Our ref: PC/22560~01

20th February 2025

RE: 53 OAKLEY SQUARE, LONDON NW1 1NJ

Photograph 1: tell tale monitor installed across junction

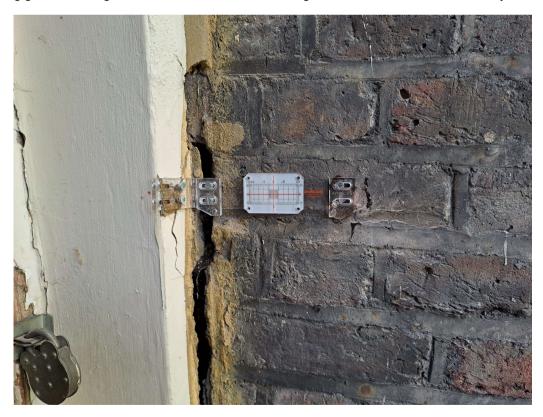
Having looked at the data from the corner tell tale, this is quite unexpected. This shows movement varies between a maximum of -7mm (crack closing and getting smaller in width) in December 2024 and +14mm (crack opening and getting wider in width) in October 2024. I have formulated a table below showing the movement over the period of monitoring.

The one noticeable trend is that the crack gets wider in the summer months and closes up again between late autumn and spring. This would lead us to conclude that in the summer months, the clay sub soils under the rear extension shrink in volume due to ground water being extracted from the large trees in the back garden. As the clay sub soils shrink in volume, this causes the rear extension to drop and rotate away from the rear wall of the main house, causing the crack to widen. In the wetter months, it appears that the clay sub soils rehydrate and expand in volume, pushing the rear extension upwards and causing the joint or crack to close.

The readings in November, December and January in 2023/ 2024 and 2024/ 2025 are very similar and moving in the same direction. This would lead us to conclude that the movement is cyclical and seasonal. The data suggests that the movement is not progressive ie, continually getting wider and not recovering.

From reviewing the data, it is likely that the roots from the large trees in the rear garden extend under the foundations of the rear extension and this is leading to changes in moisture content of the clay sub soils which then causes expansion and contraction of this material which then leads to differential movement of the extension in relation to the main house.

There are a number of options available to remedy this problem. The first is to carefully manage the trees and prune them back. This will result in them extracting less moisture from the ground under the rear extension and therefore the moisture content of the sub soils will remain constant which will prevent the seasonal changes in volume of the clay sub soils.

The second option would be to underpin the rear extension. This would involve excavating under the existing foundations and pouring new foundations that would extend to a depth below the ground that is affected by tree roots. This option is disruptive, costly and time consuming and is normally only considered as a last resort.

The preferable option would be to manage the trees and continue to monitor the situation. This would involve appointing an arboriculturist to survey the trees and provide advice regarding appropriate measures for pruning and managing the trees. If the council owns the trees, you will need to contact them and ask them to carry out the works. If the tree is owned by the freeholder, they are responsible for the management of the trees.
